APPEAL SUMMARY

Appeal ID: 15363	Project Address: 514 SE Belmont Ave
Hearing Date: 7/12/17	Appellant Name: Brad Bane
Case No.: B-019	Appellant Phone: 5039521529
Appeal Type: Building	Plans Examiner/Inspector: Brian McCall
Project Type: commercial	Stories: 7 Occupancy: A-2, A-3, B, R-2, S-2 Construction Type: Types III-A over Type I-A
Building/Business Name: Grand Belmont	Fire Sprinklers: Yes - Throughout project
Appeal Involves: Reconsideration of appeal	LUR or Permit Application No.: 16-211613-LU
Plan Submitted Option: pdf [File 1] [File 2] [File 3] [File 4] [File 5] [File 6] [File 7] [File 8] [File 9] [File 10] [File 11]	Proposed use: Mixed-use: Retail, Multi-Family Housing, Parking

RE: Corridor Fire Rating
Capacity of Framing Assembly
River Place Parcel 3 & Grand & Belmont

White Paper - Fire Analysis of Fire Retardant Treated Wood Alternate

1 LEVEL 3

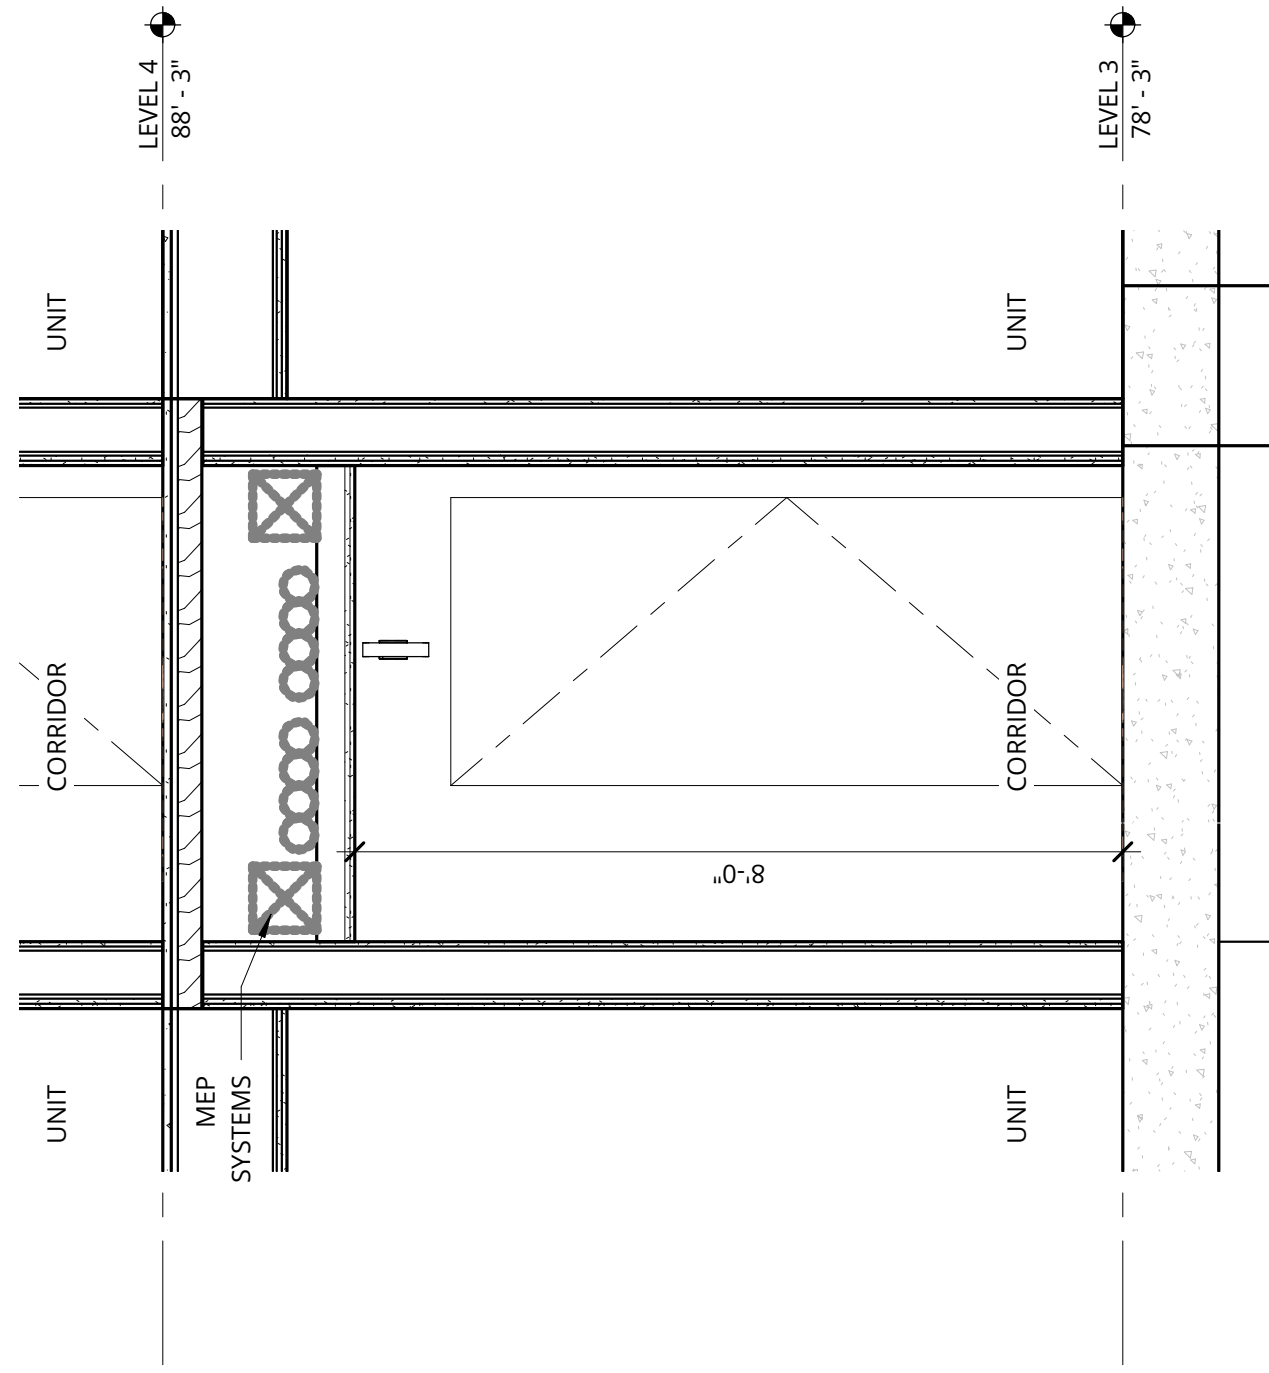
The thinner floor thickness provides adequate room for sprinklers, ducting and other necessary utilities above the non-rated ceiling without increasing the overall building height. In addition, this allows penetrations at the ceiling to be non fire-rated. See Exhibits D.4 and D.5 for proposed assemblies.

Reconsideration Text: We were asked to revise the char rate calculations to use 1.8" rather than 1.5" per hour and to provide plans so show the various spans for the decking. Based on the revised calculations, portions of the corridors will now be constructed using thicker decking to meet this higher char rate. This is indicated on the plans and additional construction detail.

1 LEVEL 3
1/4" = 1'-0"

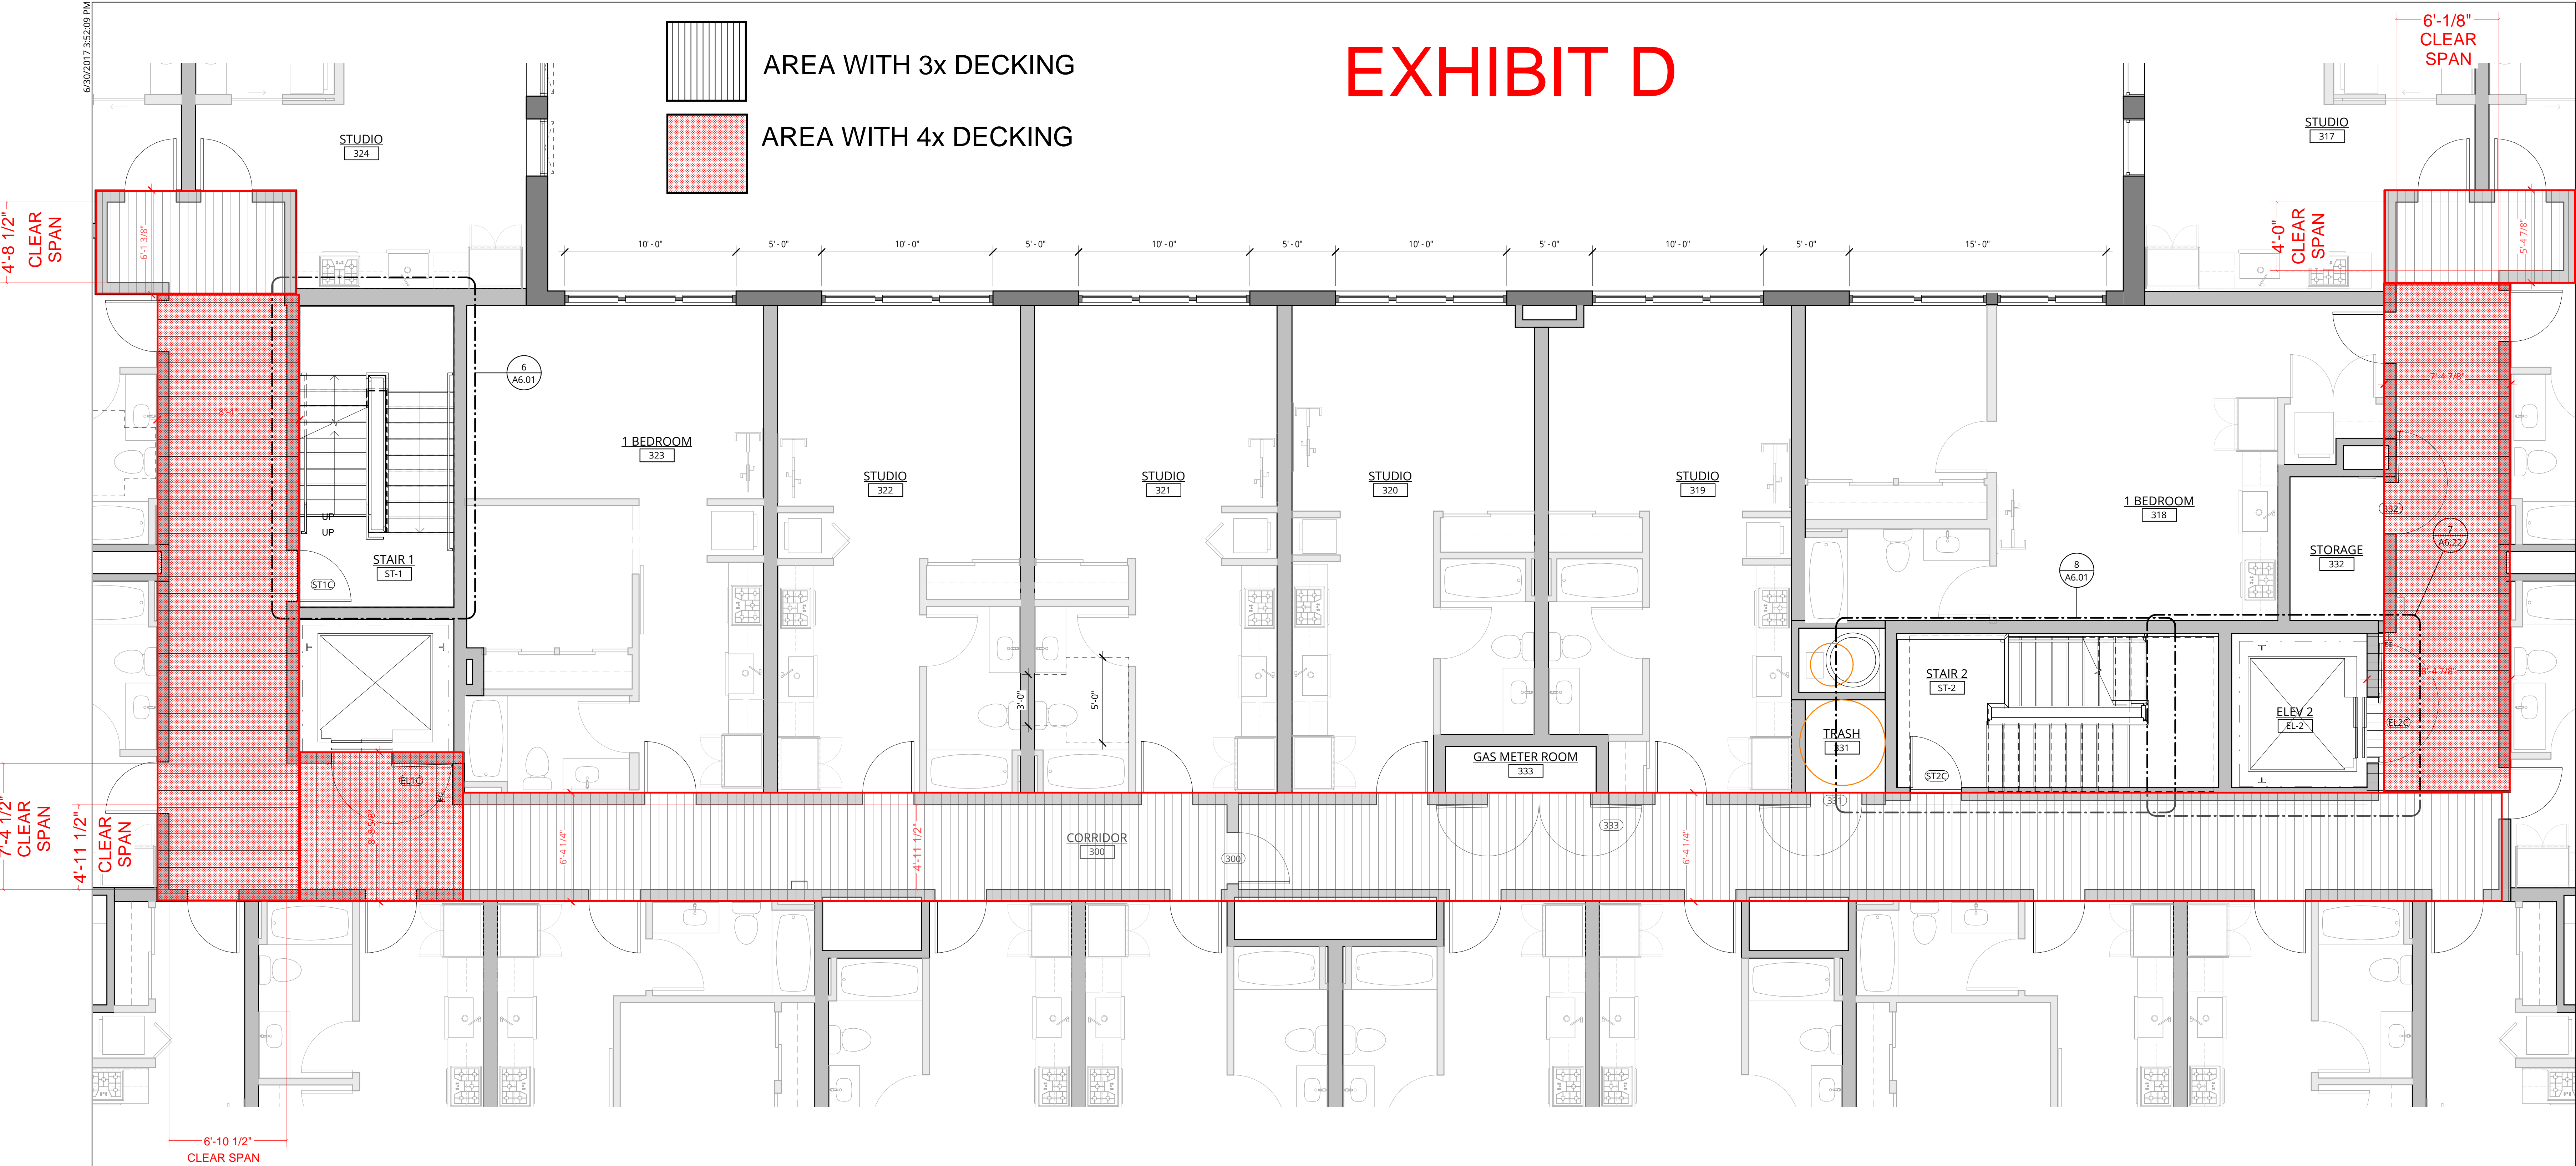
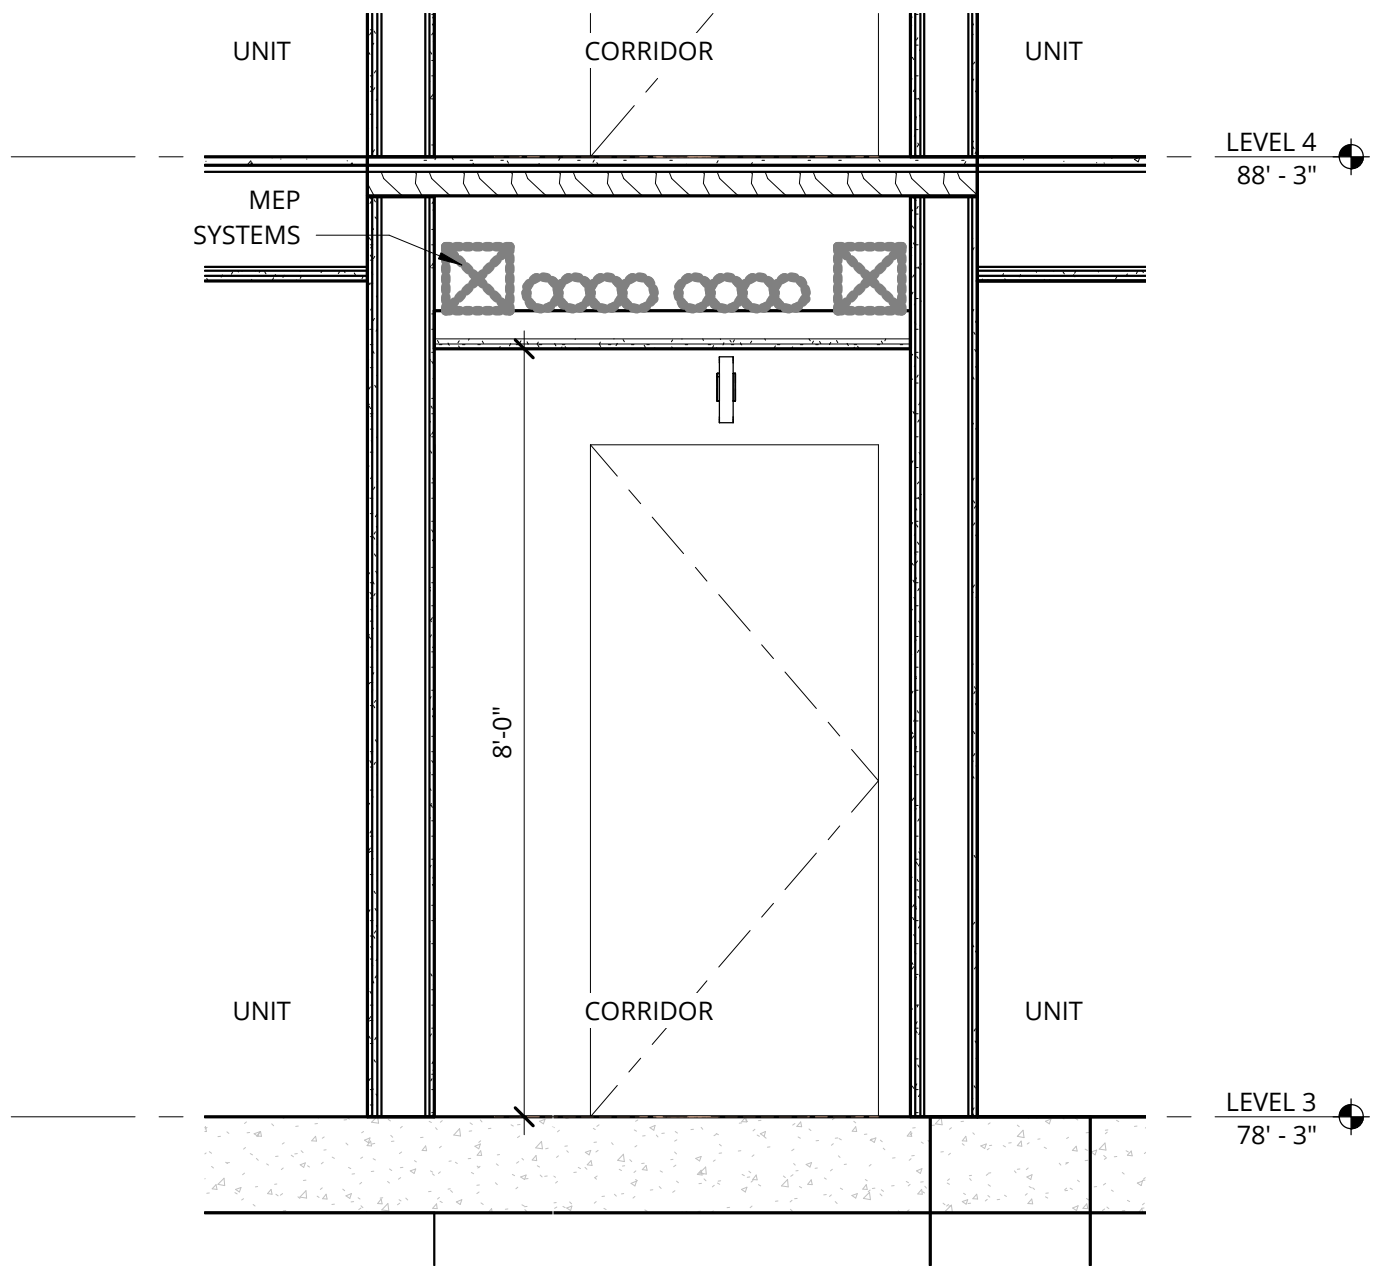
1. Alternate 1 hour fire assembly at corridor floors per engineered analysis: Denied. Proposal does not provide equivalent Life Safety protection.

2. Rock wool batt insulation with non-fire resistant treated wood in exterior walls of IIIA construction: Granted provided sacrificial studs are provided, or calculations by Oregon structural engineer showing structural members retain sufficient integrity after one hour of flame exposure to support the required load for the span proposed based on 1.8 inch effective char rate per hour.
